Review of Landfill Solar Pre-feasibility

City of Kalamunda

File: P20014-C001-003

Solar Farm - Pioneer Park

Figure 6-15: LGCs - PFA price assumption vs Futures market

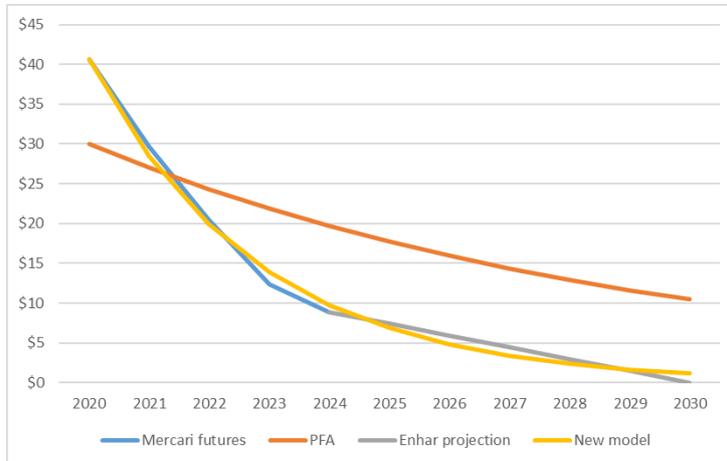
The RET scheme concludes in 2030 and there will be zero contribution from LGC after that time, unless Federal bipartisan policy emerges which supports a higher renewable energy target for Australia. Bipartisan renewable energy policy appears unlikely to emerge in the medium term however.

- Average market price paid: \$74/MWh (energy) plus \$13/MWh (reserve-capacity payments), falling by 1%/annum;
- LGCs: \$28/MWh, falling by 30%/annum with eight years to run (refer Figure 6-15);
- Indexation of expenses: 1.5%;
- Loan rate: 2%
- Discount rate: 2%
